10/21/2016

**Glynn Village Plat 10  
Waukee, IA 50263**

**Iowa NPDES 9433-9235**

## Notice of Potential NPDES Permit Violations

SEDIMENTATION BASIN MODIFICATION  
TO PROPOSED DETENTION BASIN

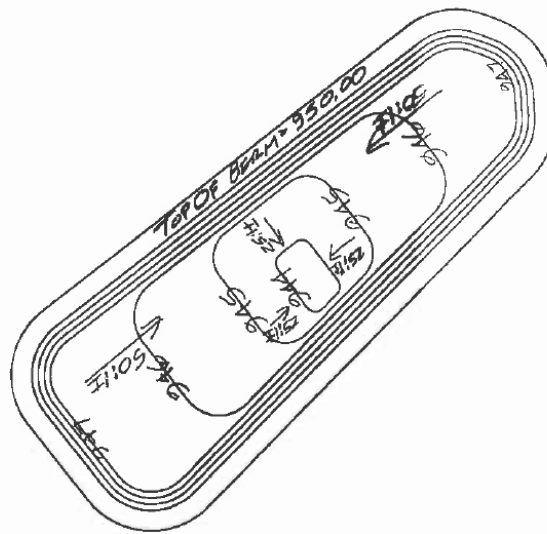
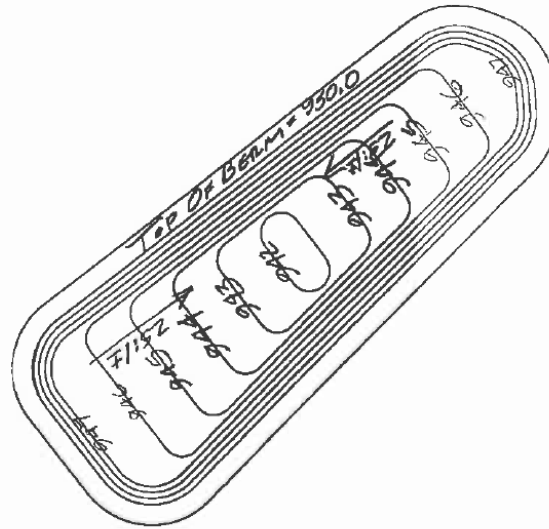
Measurements have been taken of the two detention basins. As of 10/19/16, the two basins (which were intentionally designed to have extra storage) both had 2 feet of silt storage left before being required to be cleaned out. If either basin ever reaches the maximum silt storage, we will clean them out as required by the Storm Water Pollution Prevention Plan.

It was noted during the inspection the smaller basin, Bailey West basin, had what appeared to be significant amount of sediment accumulation. However, that basin was intentionally oversized to hold 3 ft. of silt permanently, and still contains stormwater as required by SWPPP. As shown in the attached document from the designing civil engineer, the silt accumulation in both of the basins in question was at less than 25% of capacity of the basins, and the SWPPP references the need to clean out the basins once silt has accumulated over 25% capacity or at the end of the project. We have performance bonds in place with the City of Waukee to clean out each basin at the end of the construction phase and ensure any pipe infrastructure is cleaned out as well.

The Bailey West basin was designed to permanently store silt in the bottom 3 feet. That is, 3 feet of silt can remain in the basin without the need for it to be removed and still allow the function of storm water management. The detail for the basin as found on sheet 91 of the construction plans is attached.

## Exhibit C – Erosion Control Map 3 (cont'd)

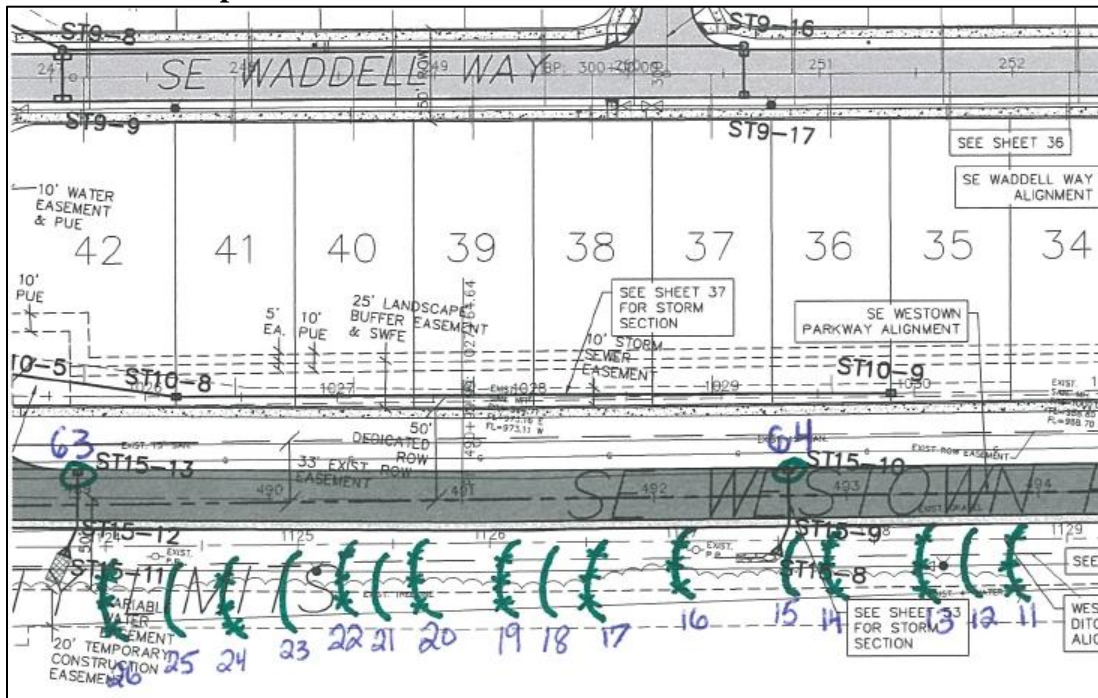
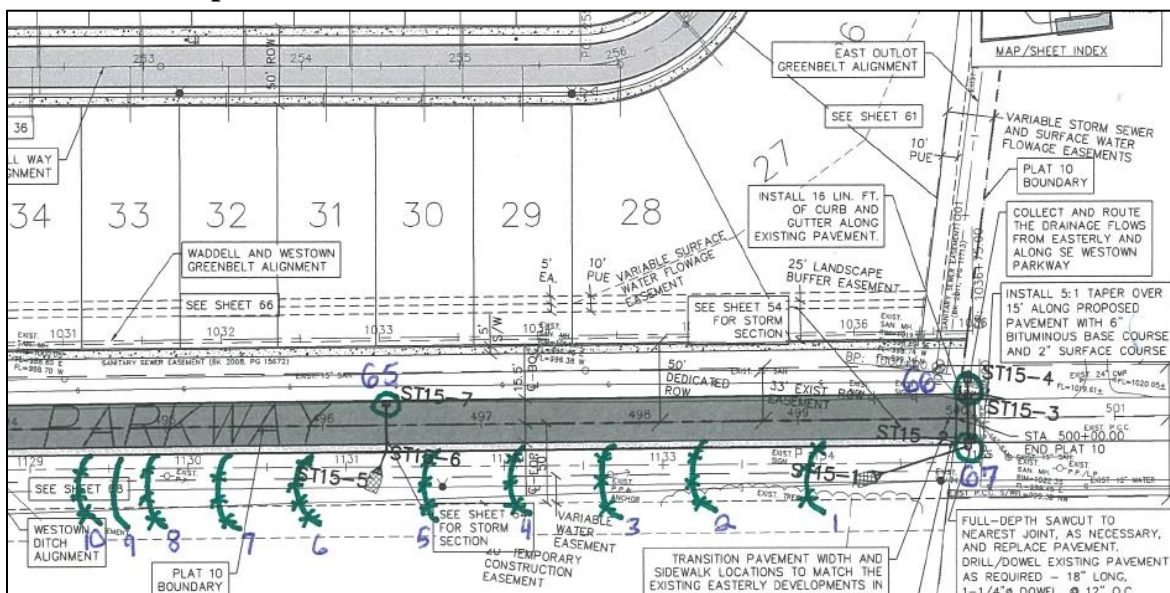
*“There were evidence of sediment runoff deposits into the unnamed tributary to Sugar Creek caused by stormwater runoff from land disturbance at the Westown Pkwy paving project site.”*

-On 10/12/16 Silt sock BMP's were placed as velocity checks in the South ditch on both the East and West side of the unnamed tributary. Silt sock was also placed at the top of the slope of the tributary as a final protective measure before the rip rap, as shown in Tidy Site Invoice #12285 (**Exhibit 2A**). For photographic evidence, refer to **Map Exhibits A, B, and C and Photo Exhibits D, E, F, and G.**

-On 10/13/16 and 10/14/16 Silt Fence BMP's were installed further protecting the top of the slope and slowing potential flows towards the unnamed tributary, as shown in Tidy Site Invoice #12287 (**Exhibit 2B**). For photographic evidence, refer to **Map Exhibits A, B, and C and Photo Exhibits D, E, F, and G.**
